January 7, 2000

This letter is in reply to your letter dated November 19, 1999, requesting additional information regarding our request to amend the Registration Certificate NR-0701-D-104-B for the SIPS probe.

Modifications to SIPS Probe NR-0701-D-104-B

Attachment 1A

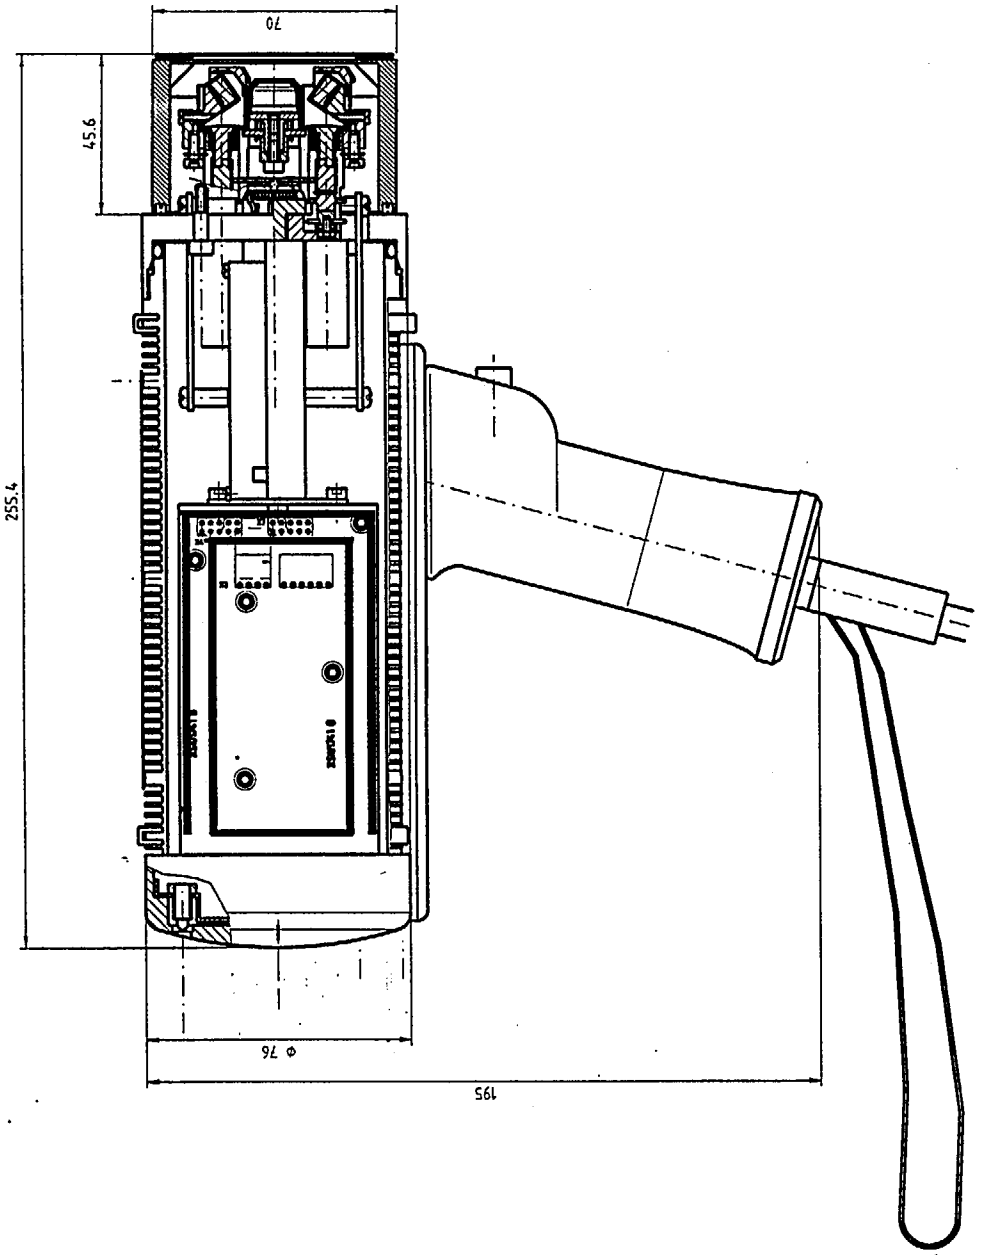
Attachment 1A (p3) is a drawing of the redesigned probe. Two external modifications have been made to the probe. First, three of the grooves in the body of the probe have been eliminated. This provides a more secure mounting for the screws that hold the radiation warning label. The second change is that a new handle has been designed which better fits the grip and includes a safety strap to minimize the chance of dropping the probe. In addition, the probe cable now enters the probe through a connector rather than being hard wired to the probe.

Attachment 2A

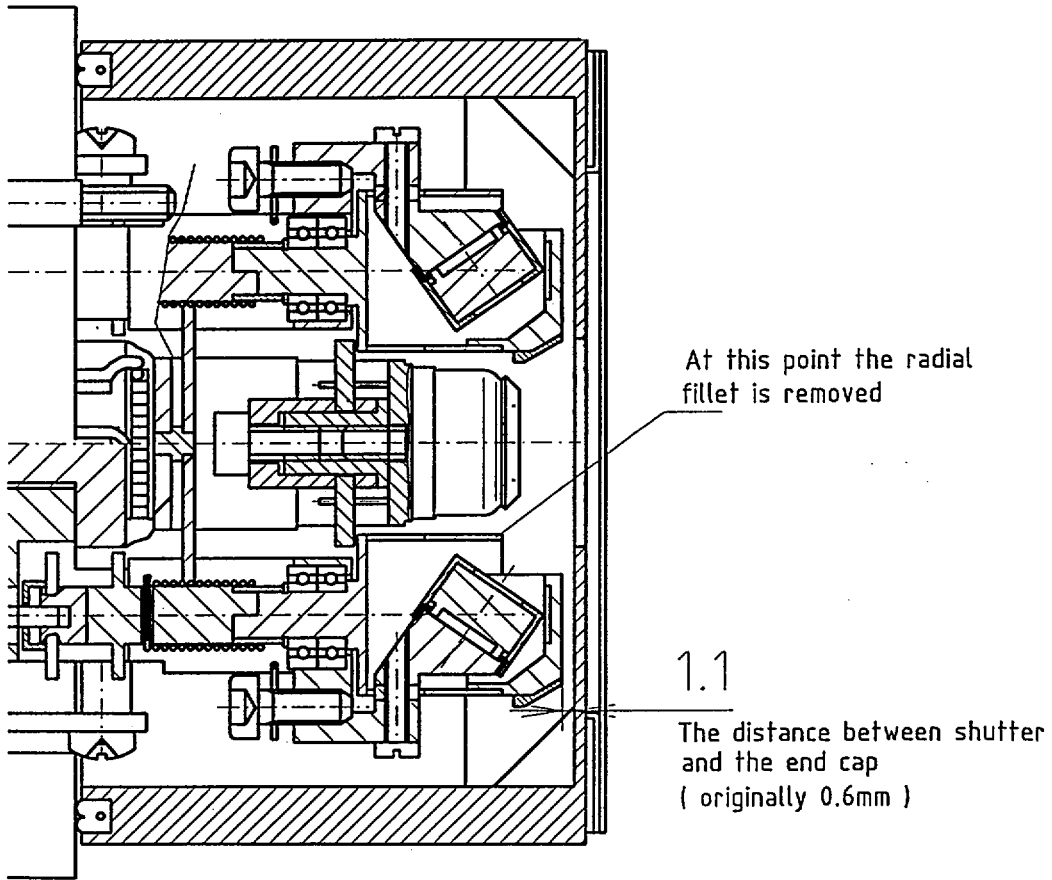
Attachment 2A (p4) shows the modification of the detector geometry. In this view, the lower shutter is opened and the upper shutter is closed. When compared to Attachment 2 (p5) from the registry, the change in the position and shielding of the detector can be seen. The detector is much closer to the front of the probe. In order to shield the detector from the source, the source housing has been modified as shown in Attachment 3A (p6) and is manufactured to drawing 4102-054-4M (p7). No other changes have been made to the source holder and/or the shutter mechanism. Attachment 4A and 4B (p8,9) illustrates the assembly of the detector, sources and shutter. The detector is attached to the source holders with two (2) plastic bridges which attach by the three holes in the detector mount and the hole in each source holder.

Attachment 3A

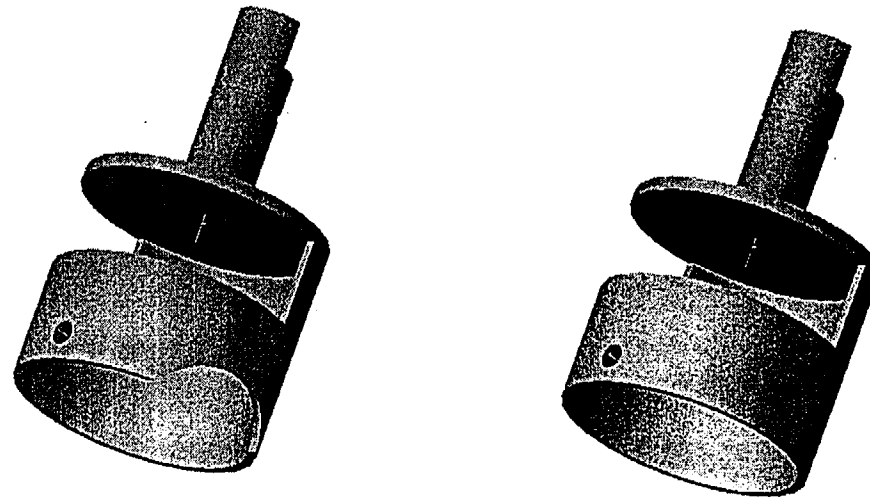
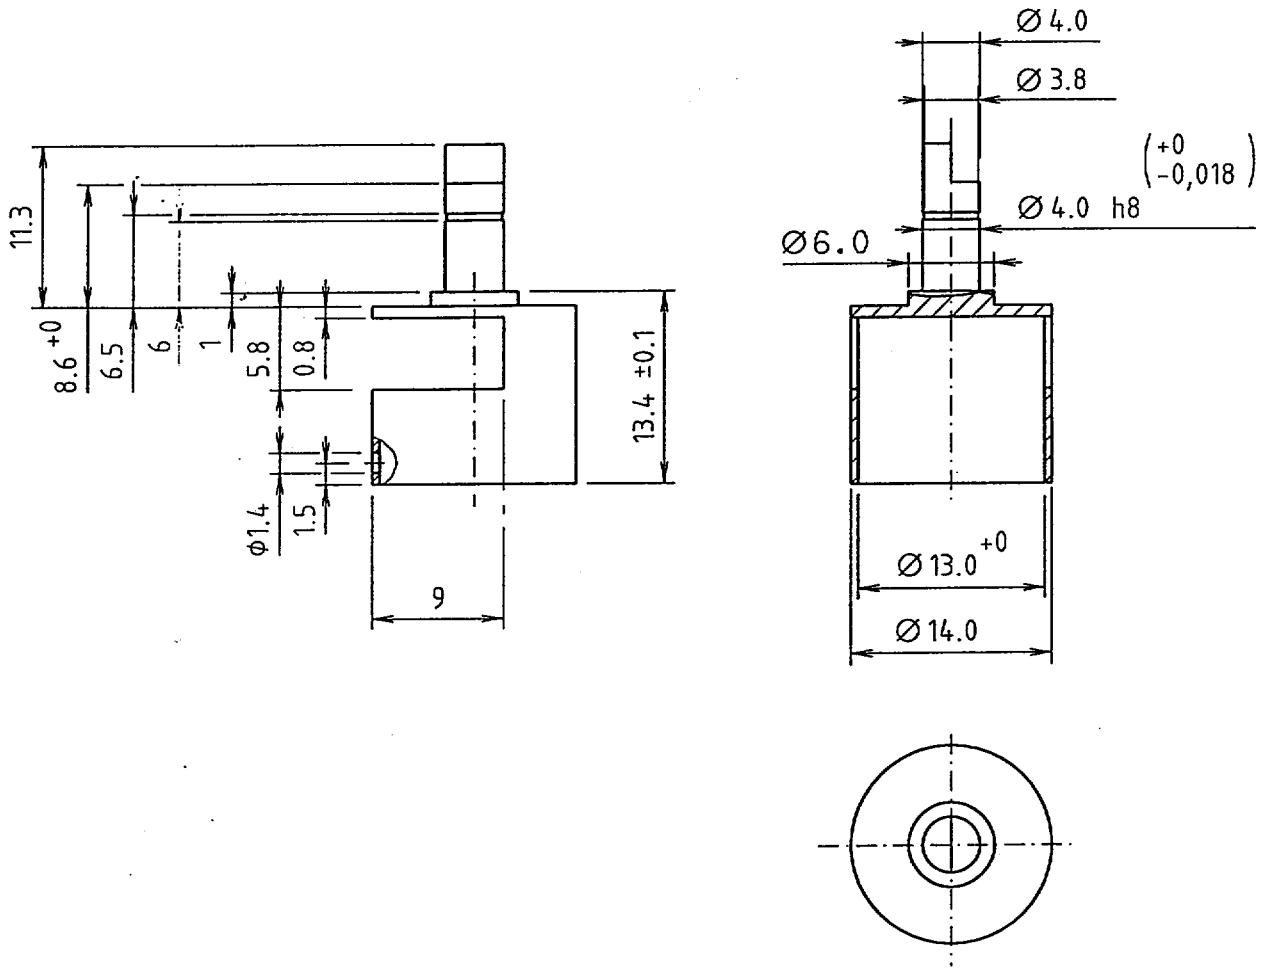
On the left old source housing
On the right the new one.

Attachment 5

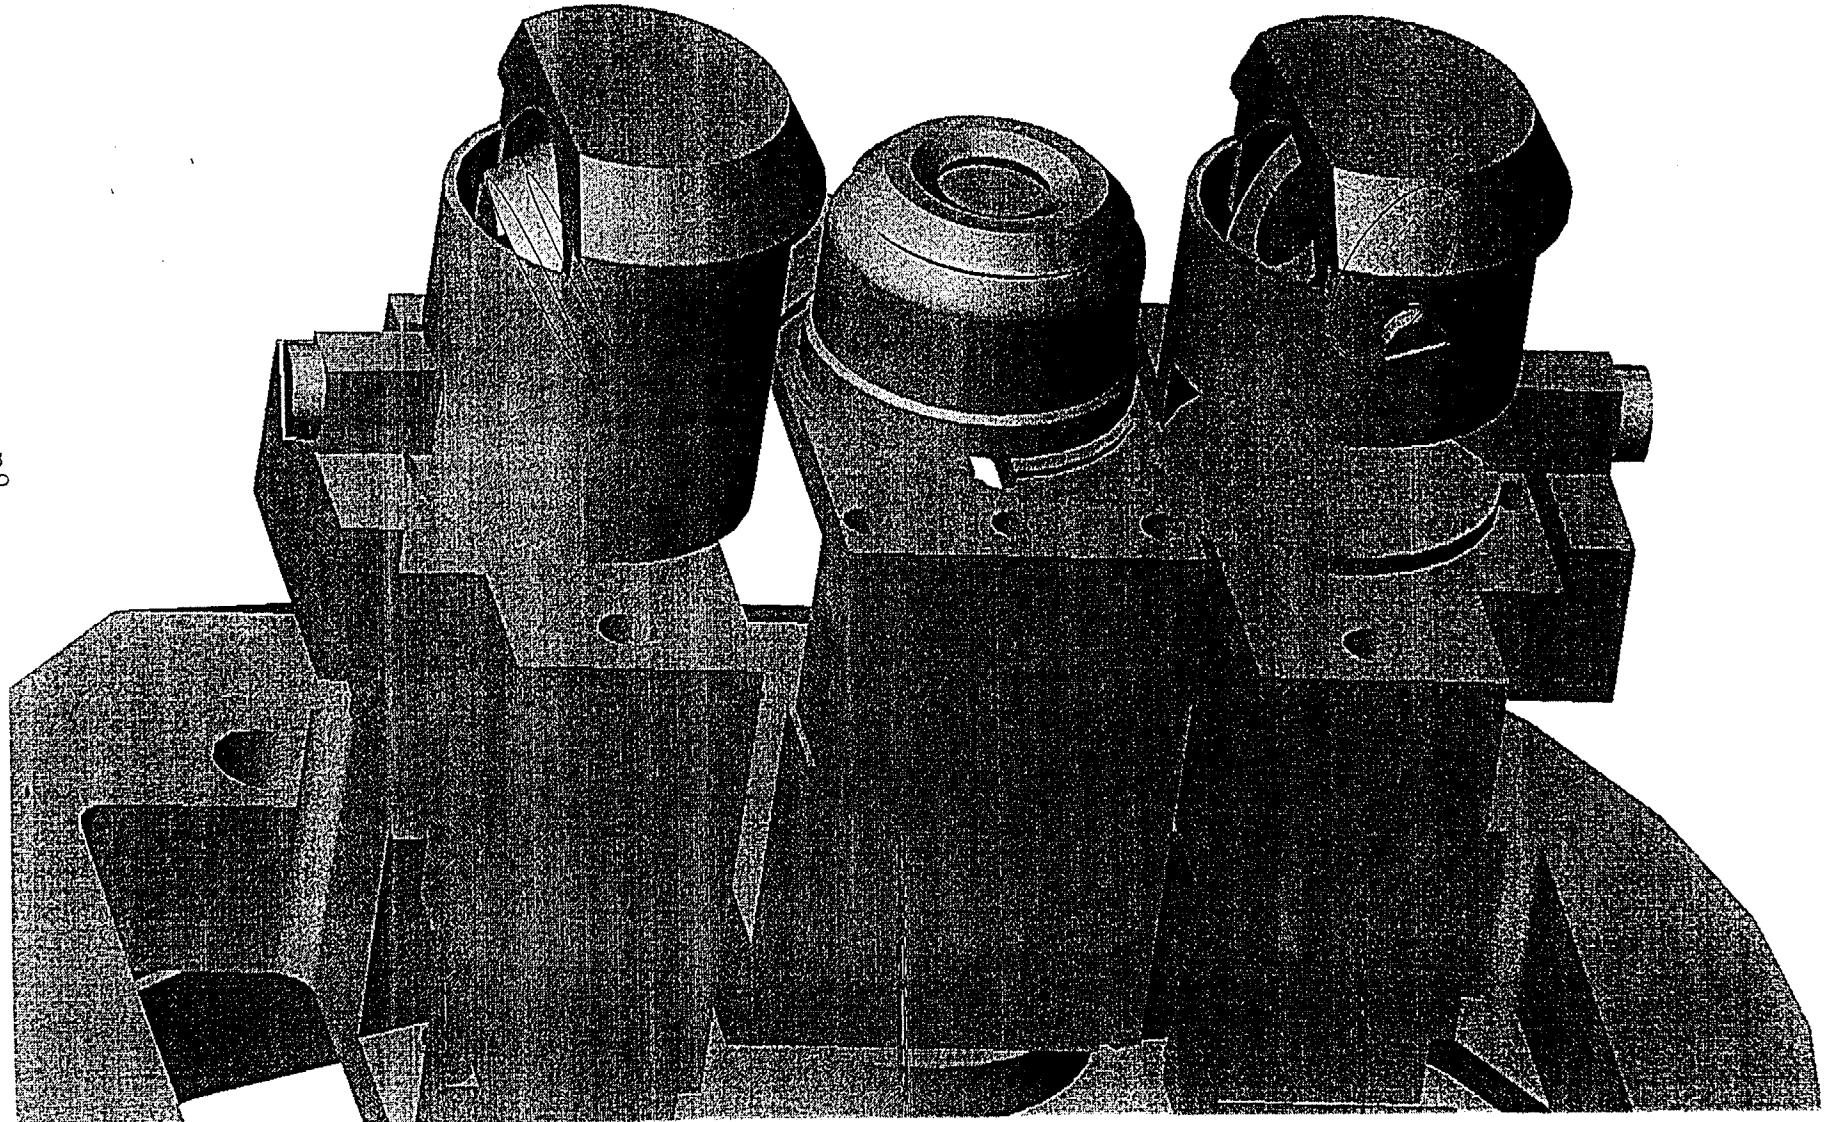
The detector limiter/shield has been changed as the shielding requirements have been reduced by new detector geometry. In instruments containing Cd-109 and /or Fe-55, a small conical ring is attached to the top of the detector as a collimator (Attachment 5 on p10). This collimator is much smaller and lighter than the limiter in the previous design. Thus, the detector will better withstand shock and vibration.

Attachment 6A

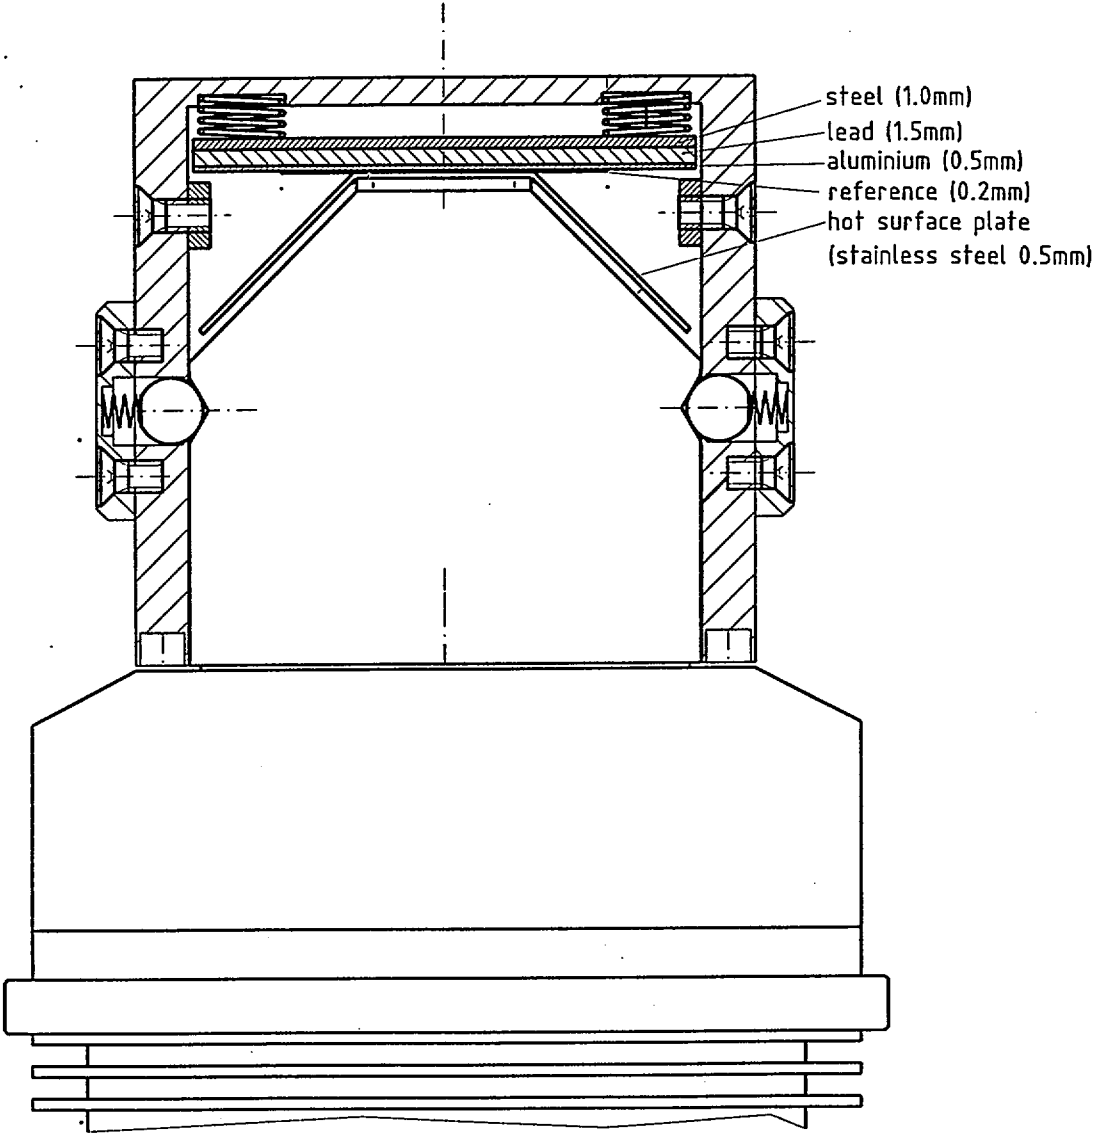
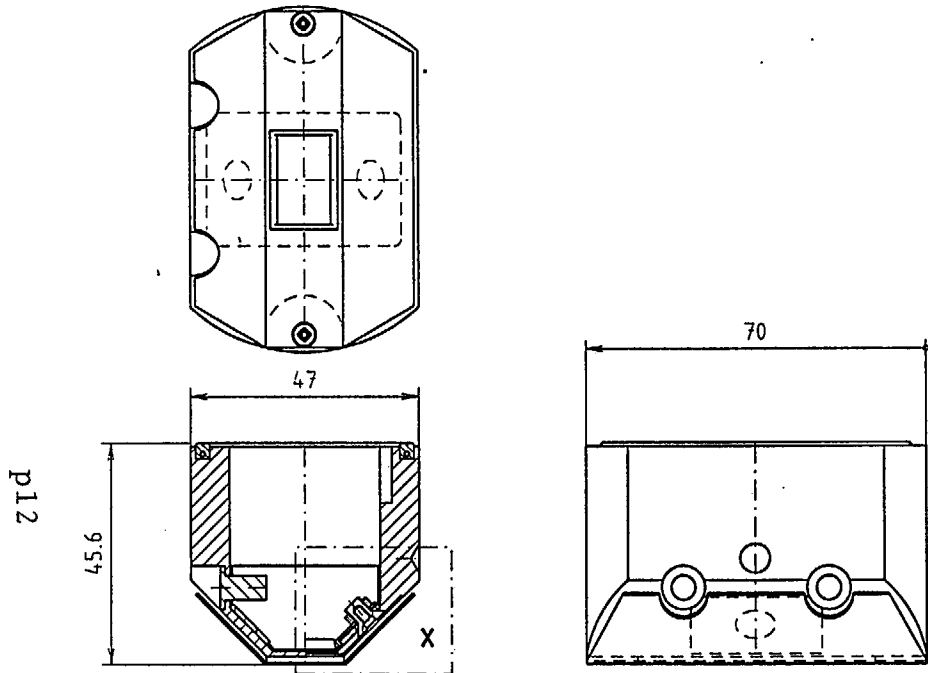
Attachment 6A&B (p11,12) illustrates the new heat shield and end cover and provide dimensions for the end cup. The heat shield (Attachment 7; p13) is an option for the unit to allow the probe to be used at elevated temperatures. The shield and associated mounting slightly separate the probe from the sample and provide some insulation. The installation of the heat shield slightly extends the length of the probe snout. Thus, with and without the shield, the probe snout will be of different lengths. This has lead to the development of a new end cover. In this version, the cover is fixed onto the probe snout with two spring loaded balls in the side of the cover. These balls fit into the small conical recesses in the probe snout. The cover is slightly longer than the old version and shielding mechanism is floating on four (4) springs. Two (2) bars on the side of the cover

limit the outward movement. The same cover is used with or without the heat shield. The shielding mechanism is sandwich composed of a lead sheet between a steel and aluminum sheet. A copper reference sample is attached to the front of the sandwich. The steel plate adds to the shielding provided by the cover when compared with the previous cover.
